Date: August 19, 2022
To: All Bidders
Project: Calabrese Park, Pendergrass Way and City Hall Improvement Project
Subject: Addendum #1
Sent Via: Posted at <https://www.sandcity.org/Home/Components/RFP/RFP/10/28>

CITY OF SAND CITY
 PROJECT TITLE: PENDERGRASS WAY, SAND CITY, CA 93955
 PROJECT TITLE: CALABRESE PARK, PENDERGRASS WAY, AND CITY HALL IMPROVEMENT PROJECT
 SHEET DESCRIPTION: DEMOLITION PLAN

DESIGNED BY: HW
 DATE: 8/19/2022
 SCALE: AS NOTED
 PROJECT NO. 1200673003 & 04
 DRAWING NO. C-06
 SHEET 6 OF 16

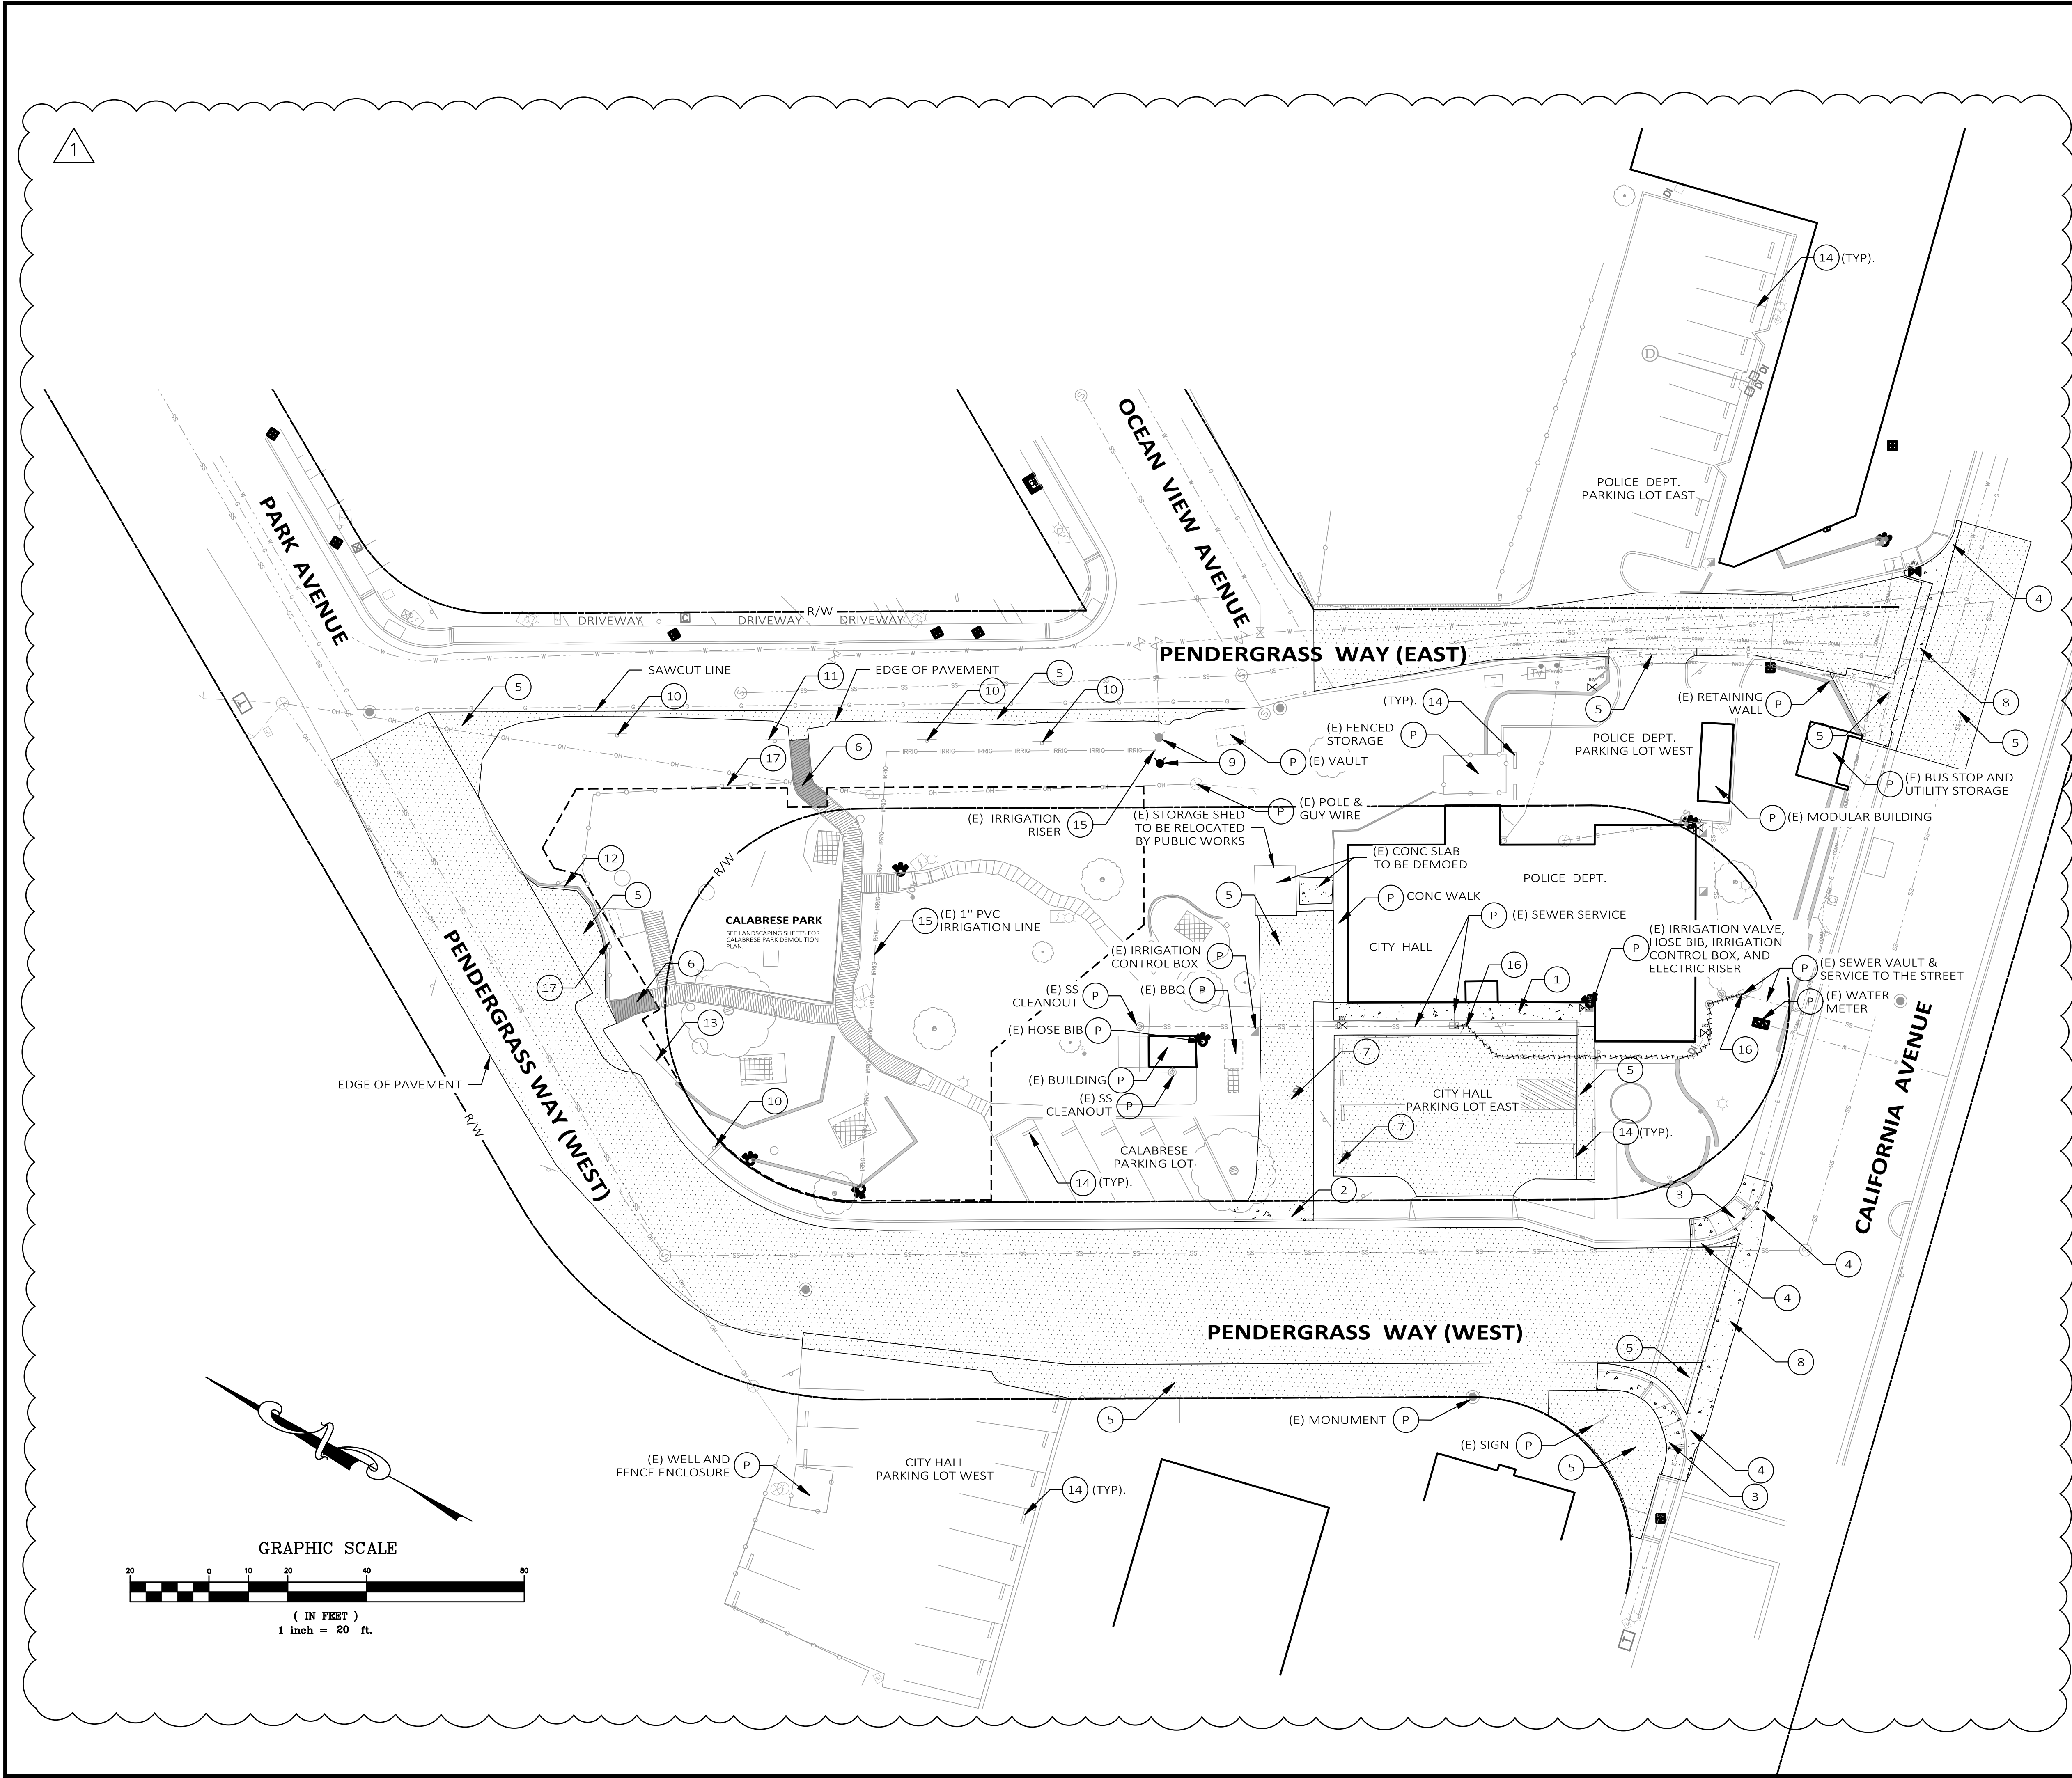
13. Question: On the Demo Plan sheet C-06 what is the difference between Existing Roadway Asphalt to be removed and off-hauled, and Demo Existing Pavement and hauled off?

14. Question: Again, on sheet C-06 the description for the used notes 17, 18, and 19 are missing from the Demolition Notes. What are these calling out?

15. Question: On sheet C-06 the callout to remove and replace the sewer (16) is used at the upper ADA parking stall. Is there sewer line here and if so is there a known length for it?

Response: The areas on sheet C-06 identified as "Existing roadway asphalt to be removed and off hauled" and "Demo existing pavement and hauled off" have been revised and combined into one item of work entitled "Grind, Remove and Dispose of Existing AC and AB" and the hatch pattern has been revised accordingly. See revised sheet C-06.

Response: Demolition callout 17 on sheet C-06 pointing to the existing wooden guard rail fence is an error and has been revised to note 13 to remove existing fencer per landscape plans as removal of this feature is part of the landscape demolition scope of work shown on sheet L-1.0. Demolition callout 18 on sheet C-06 pointing to the existing water riser is an error and has been revised to note 15 to protect existing irrigation line and riser. Demolition callout 19 on sheet C-06 pointing to the existing sewer service at the vault southeast of City Hall is an error and has been revised to reference note 16 for remove and replace of existing sewer service. See revised sheet C-06.

Response: Demolition callout 16 on sheet C-06 at this location is an error and has been revised to note 12 for removal of the existing small wooden retaining wall. No sewer service is present at the upper ADA parking stall.

1. Sheet C-06: an existing irrigation line was added to the plan with note 15 Protect Existing Irrigation Line and Riser was added to the plan.
2. Sheet C-07: an existing irrigation line was added to the plan with note 17 Existing Irrigation Riser to be relocated by City’s Public Works Department.
3. Sheet C-10: finish grade elevations at driveways were corrected. Sawcut and AC behind proposed back of walk was changed to new concrete along the west side of Pendergrass Way (West) and the hatch pattern in the legend was updated. Hatching at area of sawcut at Pendergrass Way (West) and California Ave. was changed to match the legend.
4. Sheet C-14: finish grade elevations at the new curb returns at Pendergrass Way (West) and California Avenue were revised.

DESIGNED BY: HW
 DATE: 8/19/2022
 SCALE: AS NOTED
 PROJECT NO. 1200673003 & 04
 DRAWING NO. C-10
 SHEET 10 OF 16

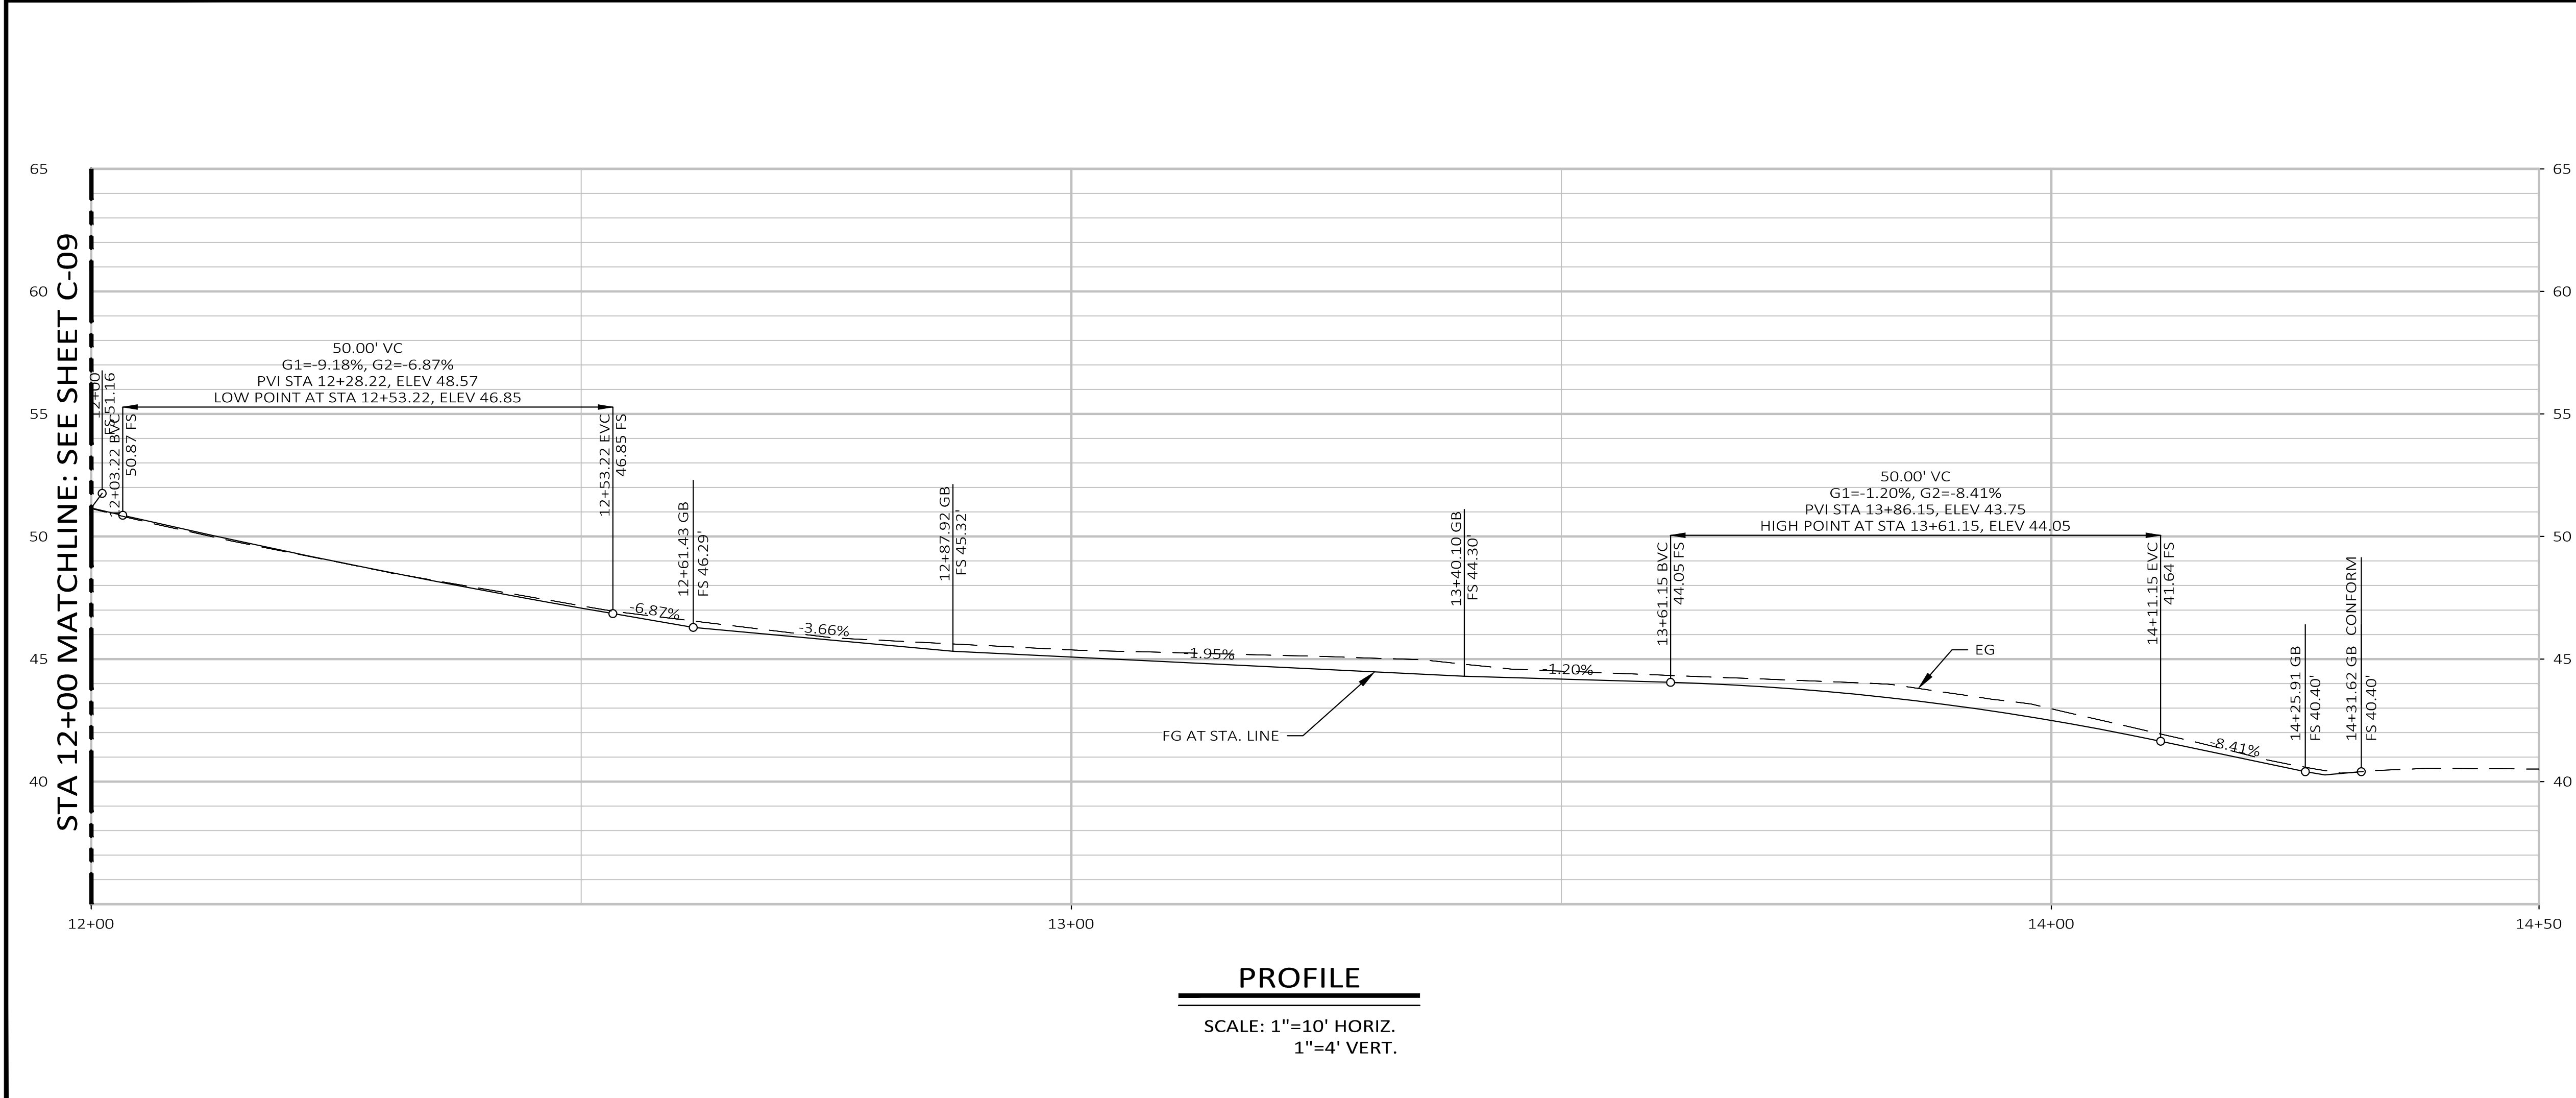
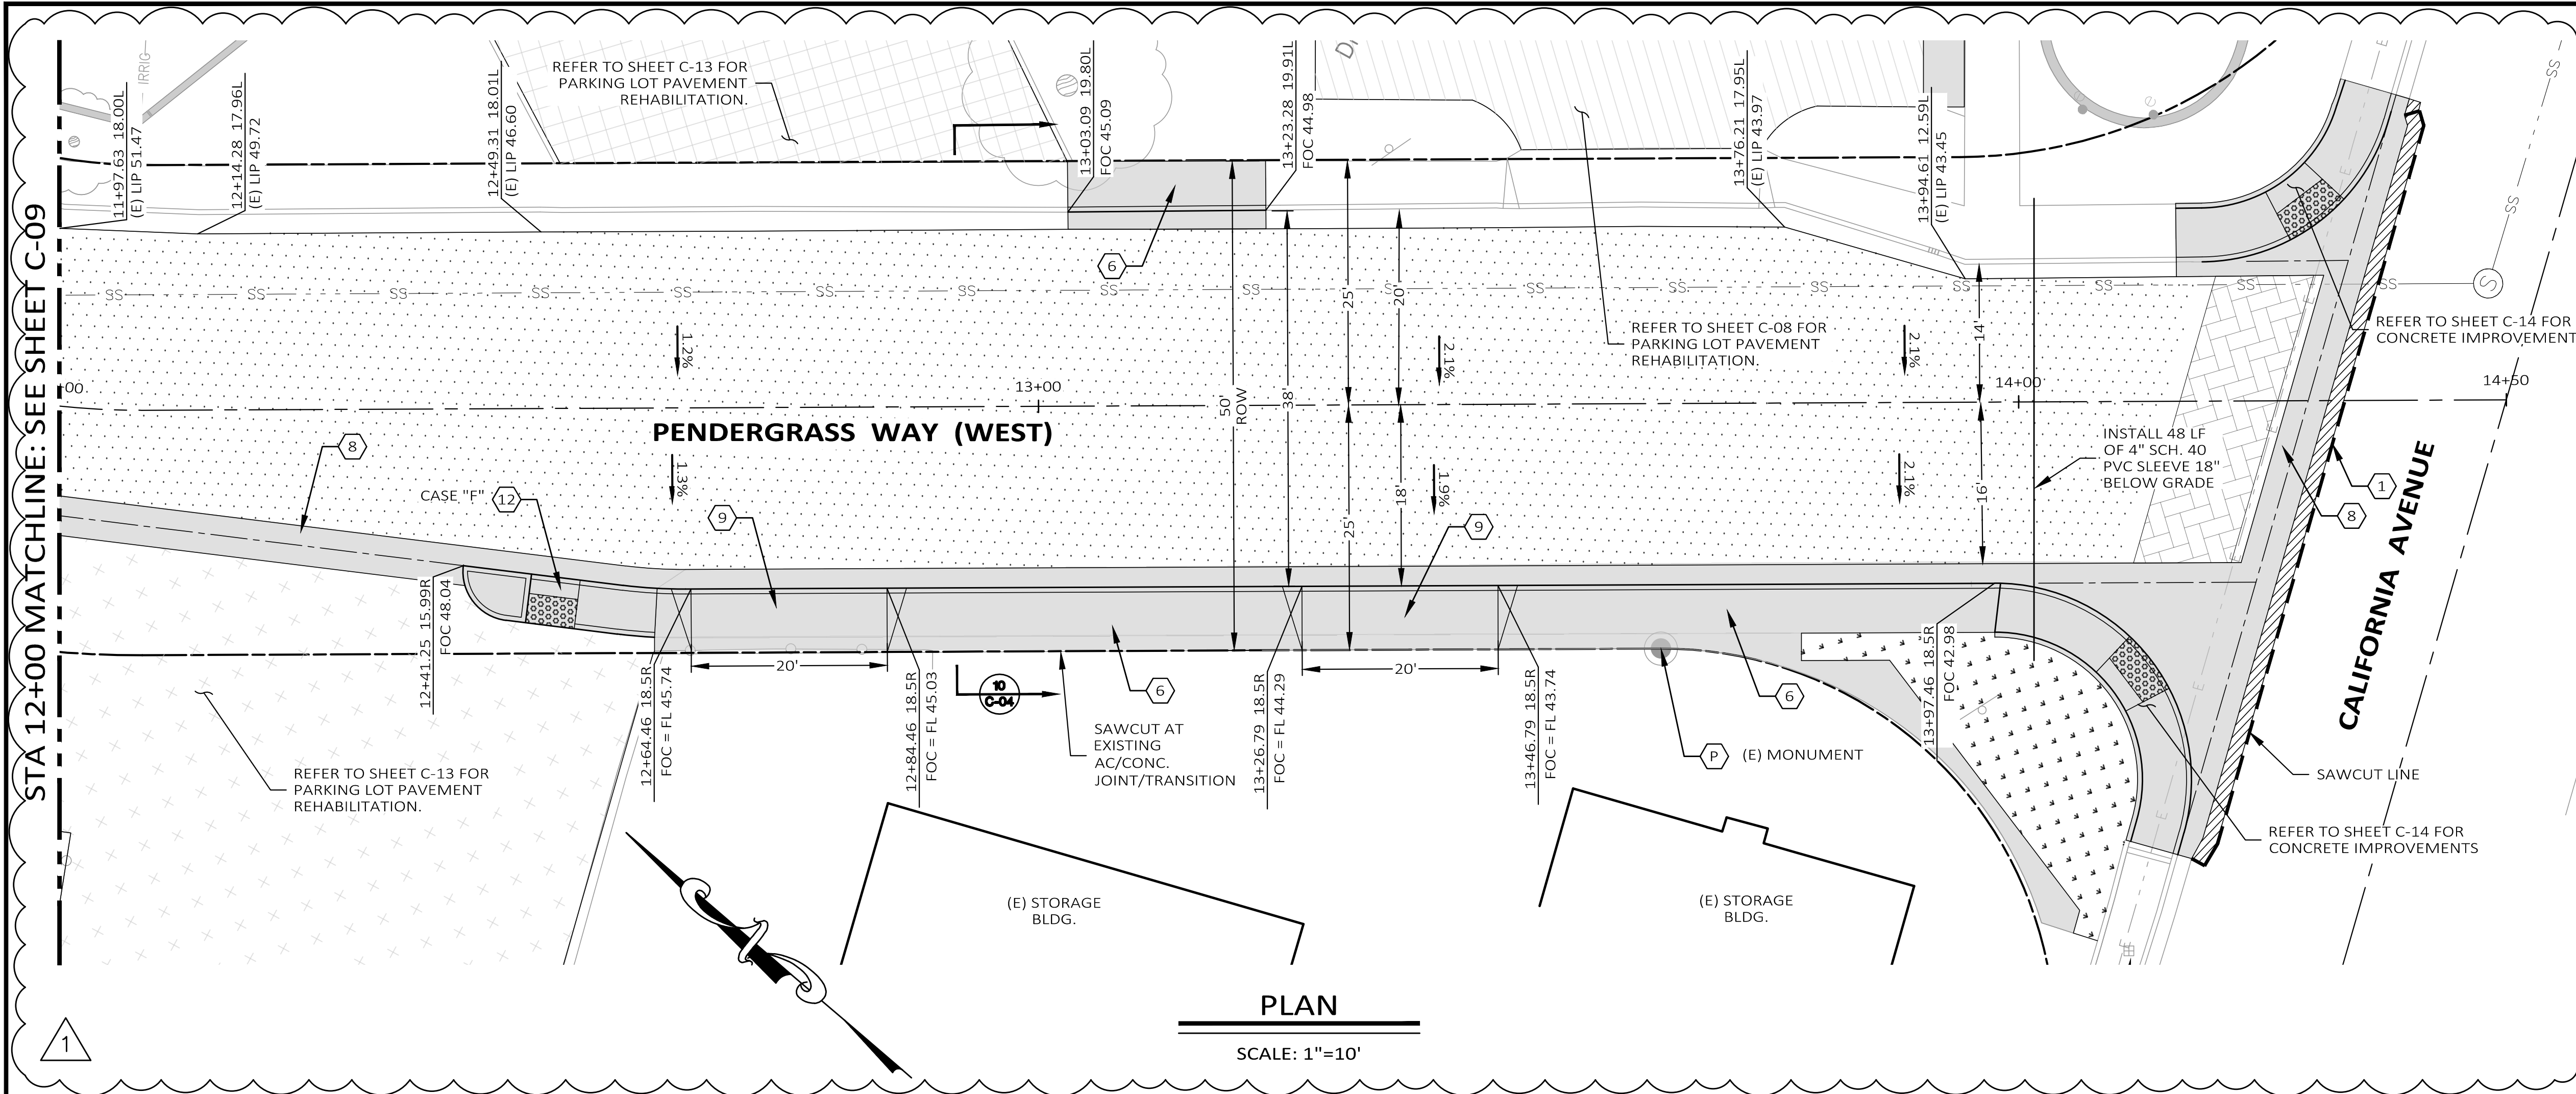
Response: Please use the Permaloc Cleanline Aluminum Edging as called out on detail 1 on sheet L-4.1.
19. Question: I'm looking at bid item 42: Stamped Asphalt Crosswalk, and would like to know the intended product for the crosswalk. The plans call for "Colonial Red," which is similar in name to "Colonial Brick," a TrafficPatternsXD (preformed aggregate-reinforced thermoplastic by Ennis-Flint) color. The specs call for a minimum hardness of 6 on the mohs scale, which is the hardness of TrafficPatternsXD. However, the specs also say that the crosswalk "shall match the adjacent cross walks to the satisfaction of the Engineer." The other crosswalks in Sand City are either stamped concrete, or StreetPrint (epoxy-modified, waterbased, cementitious coating) stamped and colored asphalt. Both products are anti-

slip/anti-skid, and are resistant to chemicals. Neither product can be “mixed” to have 2 colors. Please clarify the intended product for this application.

Response: The intended product should match the decorative stamped asphalt crosswalks on Hickory Street which is across California Avenue from the project site, which are StreetPrint stamped and colored asphalt concrete. The pattern shall be herringbone and the color shall be “Chestnut Brown” not Colonial Red as noted on the plans. Please refer to the revised plan sheets C-10 and C-14.
